# Viyallatex Ltd.

297 Khairtul, Tongi, Gazipur, Bangladesh  
(23.921026N,90.387509E)

7 December 2013

# Observations

## Additional storey

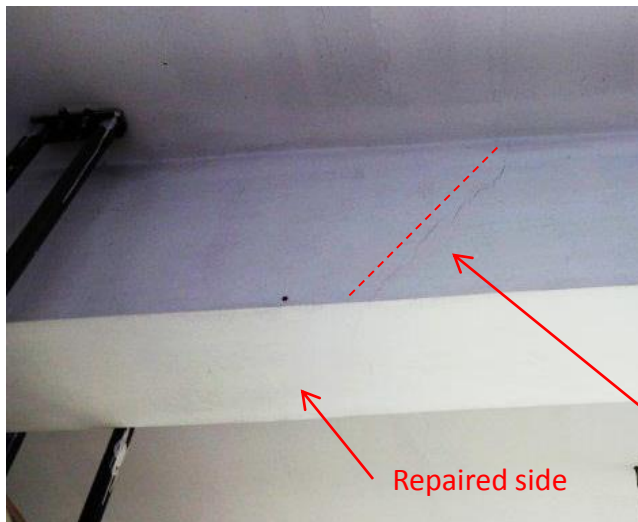
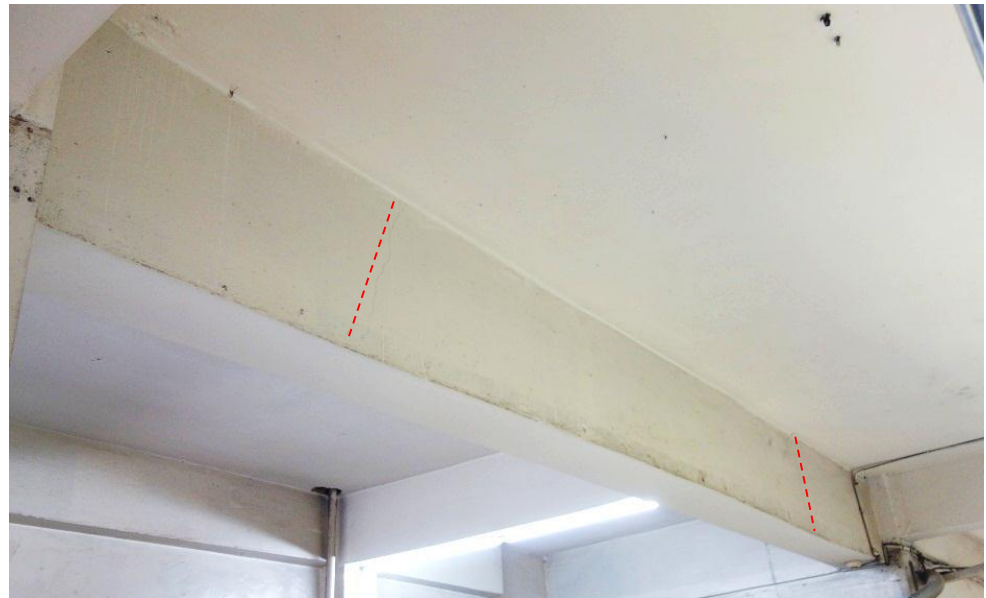
**No Permit documentation for 8 storeys + helipad**

Permit drawings show a 7 storied building.  
2 additional floors have been built (extension occupies 10% roof area)  
The jacketed columns are not below this area

## Cracking in beams and slabs

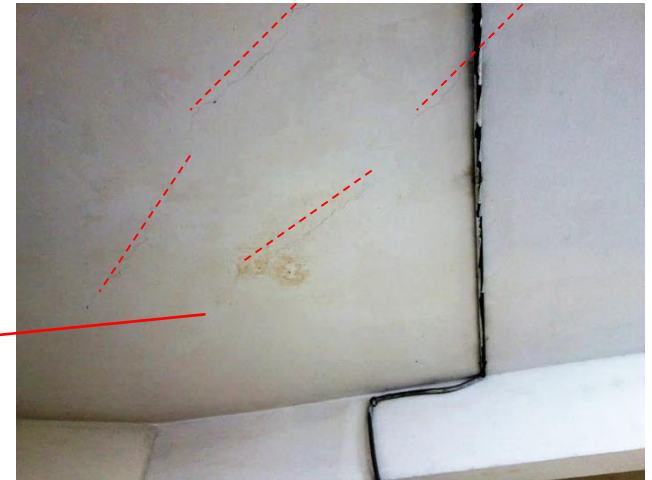
Some cracks on beams detected. General repair and painting on cracks made recently. Most beams with new plaster on bottom side.

Factory has certificates indicating crack are in plaster not in concrete. Many of the cracks appear to be shrinkage related - others not. Building Engineer to ensure inclined cracks on beams are only in the plaster

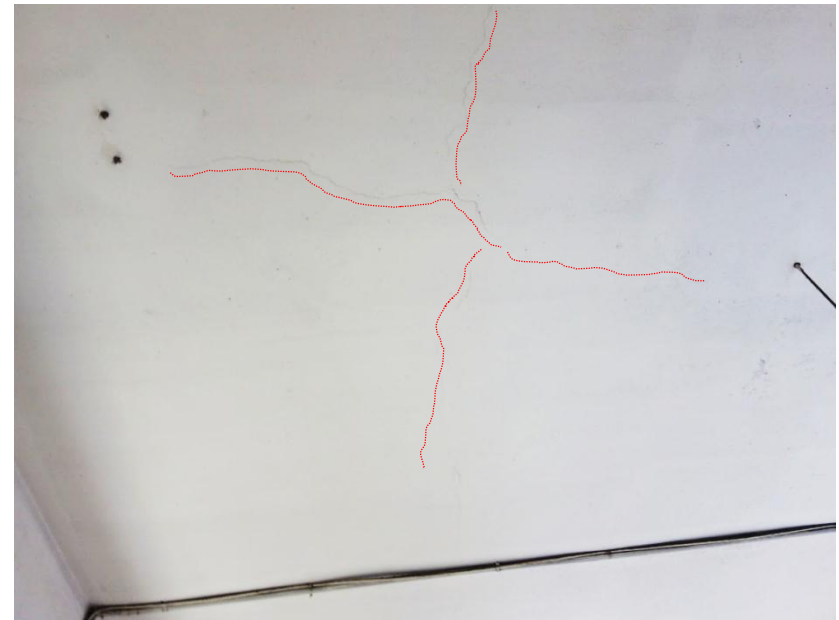
Moisture indicates cracking is not only in plaster. Water comes from upper floor

Building Engineer to check cracks in slabs and define a repair system if required

## Documentation Issues

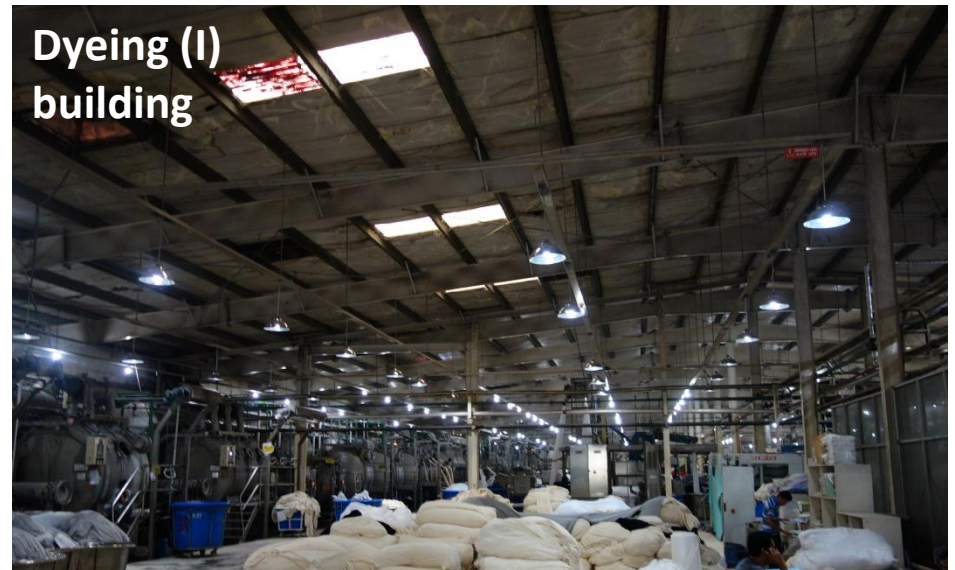
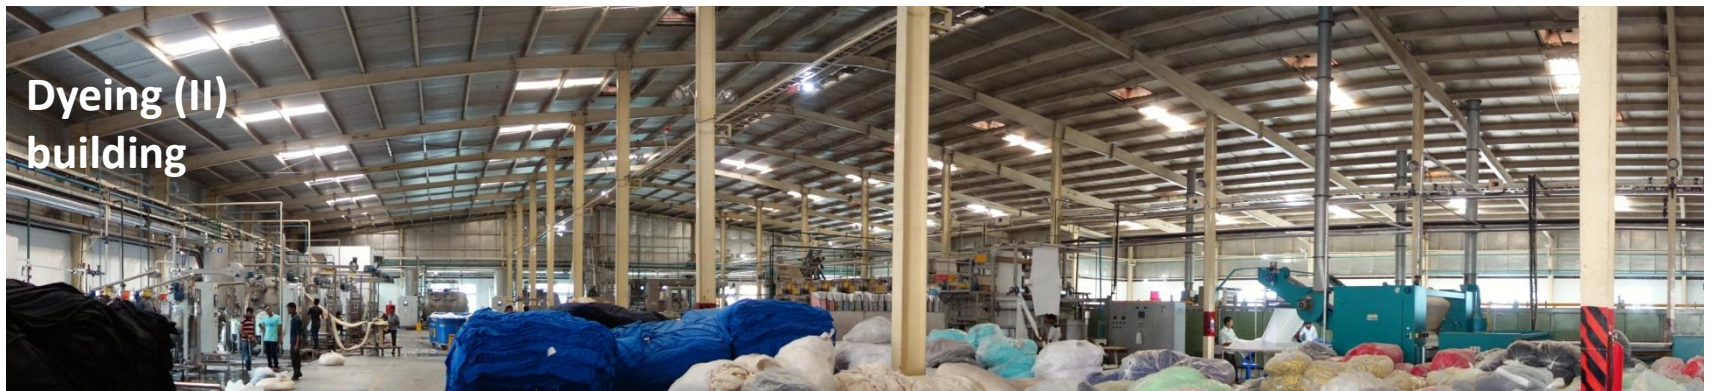
**Structural drawings were not shown for sheds, Unit-1 roof and Unit-2 roof**
